转发：ECN0004261-2.0 滑块托架结构更改通知书

主题：ECR0008586-2.0 滑块托架结构更改

此为SQX3000-6805318-左滑块托架，结构变更的ECR、数据、图纸请查收：

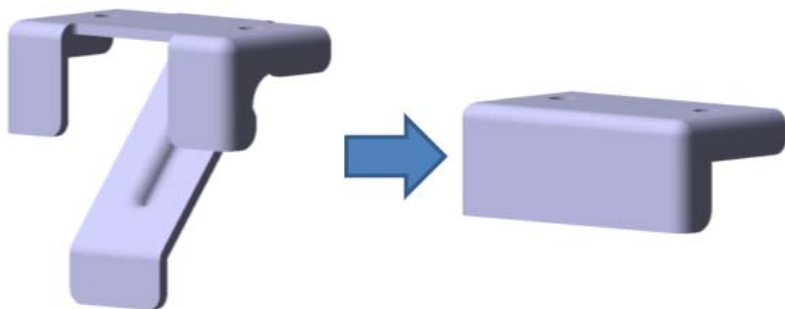
涉及座框总成增加焊道：SQX3000-6805300、SQX3000-6805336、SQX3000-6905610、SHT0014512

涉及内框分总成增加焊道：SHT0015079、SHT0015080、SHT0015081

焊道更改:

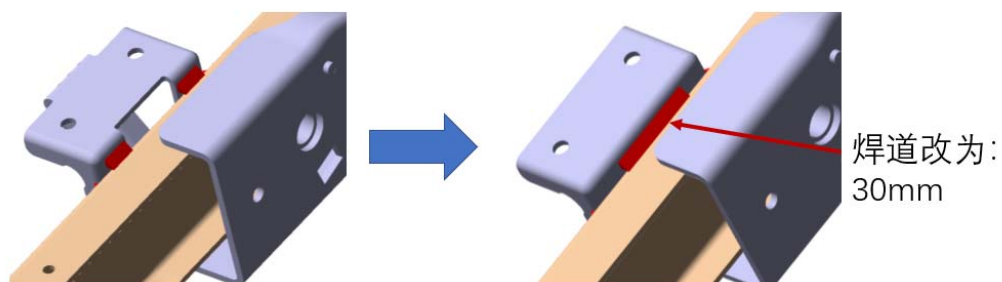
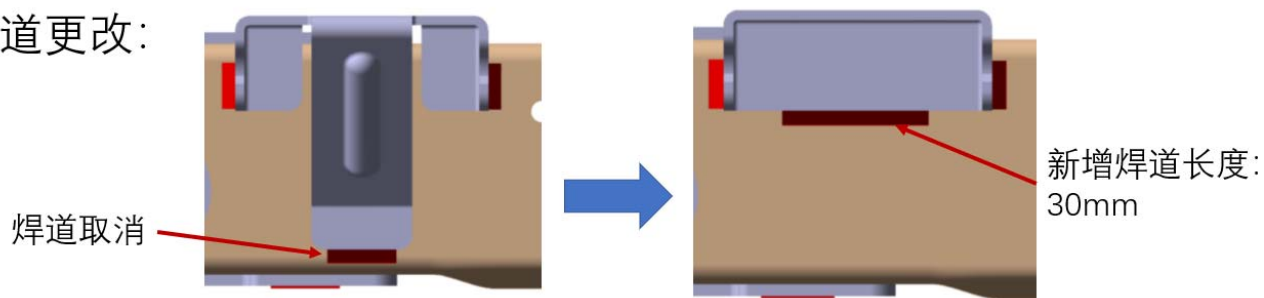
SQX3000-6805318-滑块托架数据、图纸先行下发，后续补发剩余数据、图纸
焊道更改如下图，SHT0014512数据可供焊道更改参考
